**GRUMMAN AMERICAN AVIATION
CORPORATION**

SERVICE BULLETIN NO. 146
"FAA DOA EA-4 APPROVED"

SUBJECT: FIREWALL RIVET INSTALLATION

SERIALS AFFECTED: All Model AA-1 and AA-1A, AA1B-0001 thru AA1B-0502
and AA5-0001 thru AA5-0710.

Figure 1. Firewall Rivet Installation

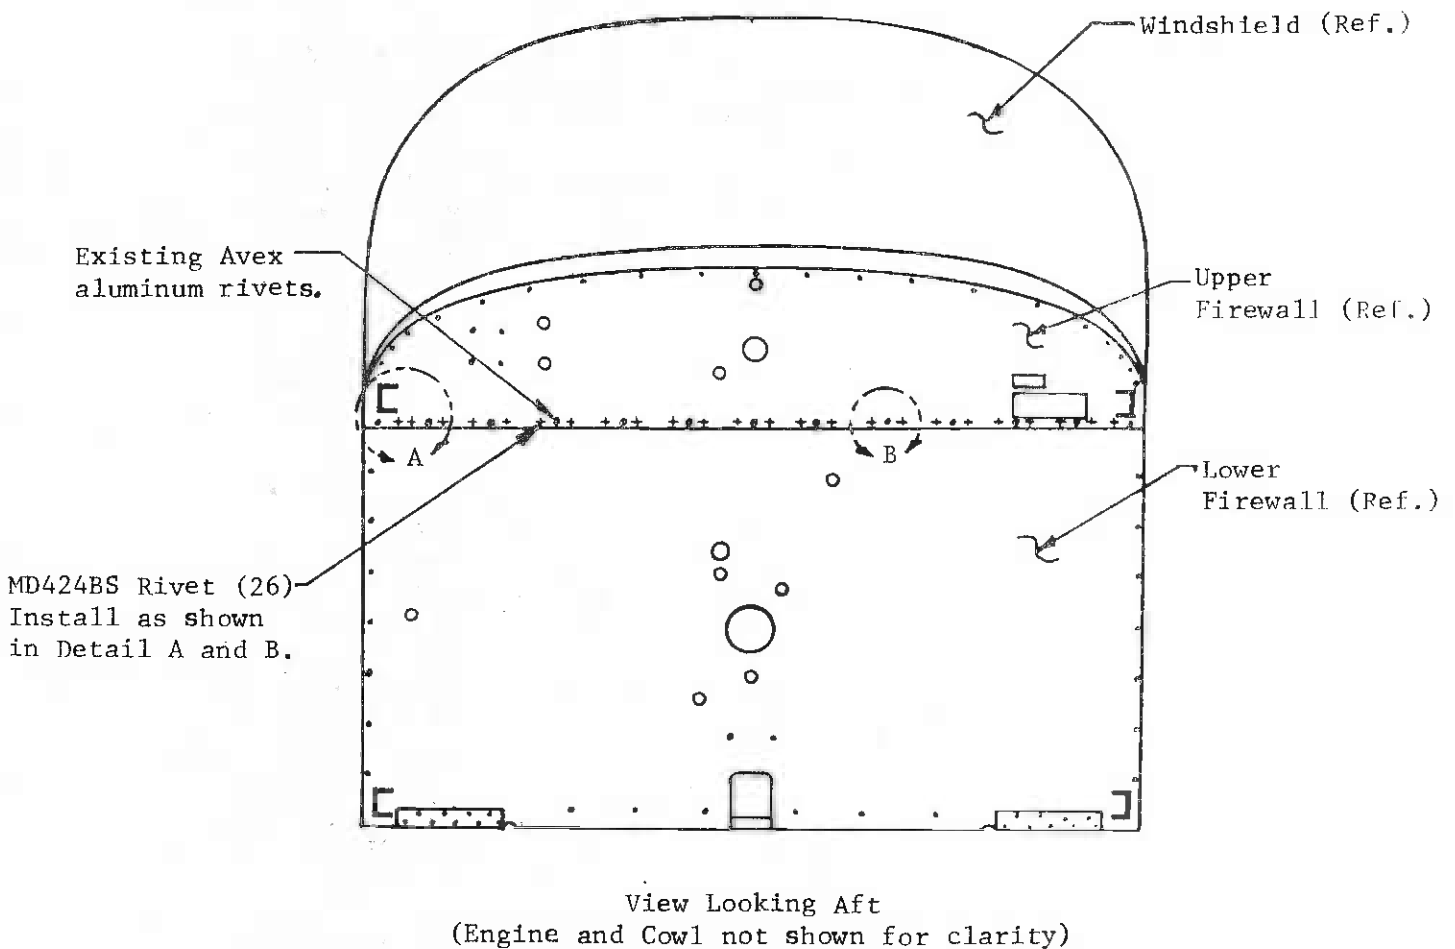
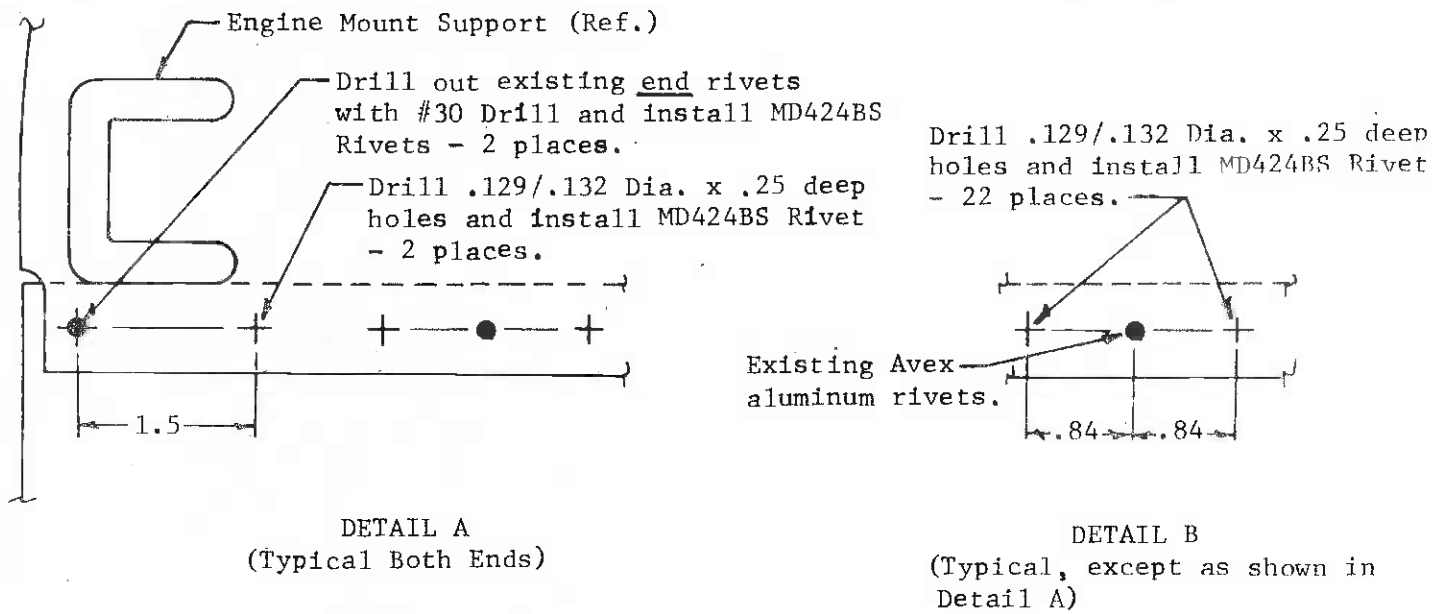
To provide increased protection in the cabin area, if a fire should occur in the engine compartment, the aluminum rivets have been replaced by steel rivets with closer spacing on current production aircraft.

In order to provide this protection on the delivered aircraft serials listed in this Service Bulletin, additional steel rivets must be added to supplement the existing aluminum rivets. The installation must be made in the time of compliance indicated.

2. Layout rivet pattern on same centerline as existing rivets and center punch hole locations as shown in Figure 1, detail A and B.
3. With a right angle drill, drill (24) .129/.132 dia X .25 deep holes that were located in Step 2. Drill out existing end rivets with a number 30 drill.
4. Install (26) MD424BS Rivets (approved alternate is Cherrylock #CR2563M4-2), using Avdel Model 735 Rivet Tool or equivalent.
